PER: DIRECTOR'S ORDER #11B "Complaint About Information Quality"

**RE: FORMAL COMPLAINT SEEKING CORRECTION OF INFORMATION DISSEMINATED BY
THE NATIONAL PARK SERVICE CONCERNING NCPC 7936 Arboretum Bridge**

We are writing with concerns regarding information contained in the both the Environmental Assessment and the public presentation of 30% Design for the National Arboretum Bridge and Trail. Given the scale and impact of this project on the Anacostia River and in light of the minimal outreach to stakeholders undertaken by the project team, it is imperative that accurate and complete information regarding this project is provided to the public. Inaccurate, misleading and incomplete information has been distributed by the project team, therefore we formally request that this information be corrected for the record and the correct information be distributed to all members of the public who participated in meetings and presentations regarding the project, distributed to all agencies having jurisdiction within the Anacostia Watershed, and be posted on NPS and Department of Transportation websites. Members of the project team also provided inaccurate and misleading information in publica

Bridge Alternatives Matrix

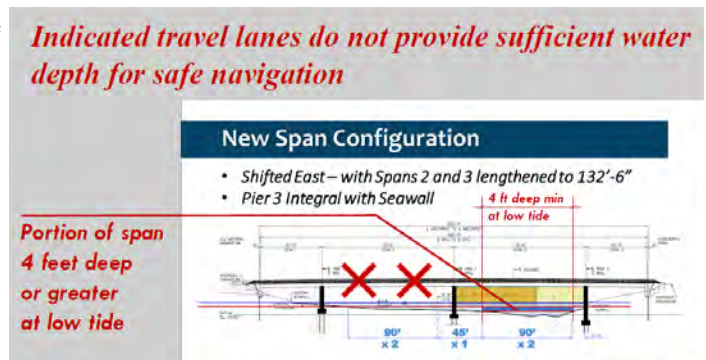
Safety was not considered an evaluation criteria

Safety of river users was not considered a selection criterion to evaluate design options.

The Bridge Alternatives Matrix was developed by the design team to justify selection of a bridge which requires piers to be located in the river, limiting the navigable channel. The matrix does not list safety as criteria for evaluation of design options. It does not acknowledge that the proposal diminishes the safety and enjoyment of river dependent activities. By admission of the design team, boaters were overlooked and omitted from outreach efforts. Concerns for the safety and experience of the thousands of visitors who visit the Anacostia by boat and use the river regularly were disregarded by the design team. Minimal effort was expended by the design team to address the concerns of visitors who engage in river dependent activities. Instead, transportation concerns, logistics and cost were the only considerations. This property acquired under the Capper-Cramton Act was set aside to ensure the protection and preservation of the region’s valuable watersheds and parklands. This land was not set aside to address transportation needs. While transportation elements can be included in plans for this property, the design of this project undermines protection of

aquatic resources and impedes provisions for river depended recreational activities and is inappropriate for the site.

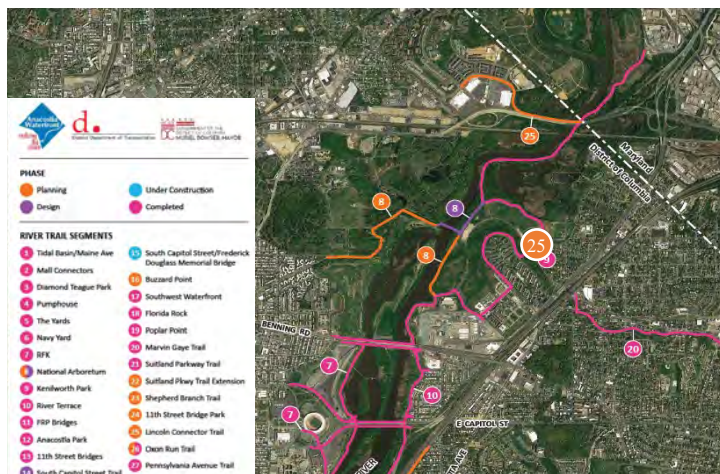
The bridge design does not provide adequate lanes for navigation. The design team asserts that the proposed bridge will accommodate four lanes of boat traffic - one span in each direction accommodating 2 boats each. This is not possible given the existing conditions as is clearly indicated by the drawings presented by the project team. The drawings at right has been annotated (by the author) to highlight the water depth which is insufficient to accommodate boat traffic in the north bound span. Therefore, the proposed design necessitates use of a single span by boats in both directions. This drawing and the following contains false information which must be corrected. These drawings and statements repeated multiple times, including in print, give the false impression that the design preserves boater safety.
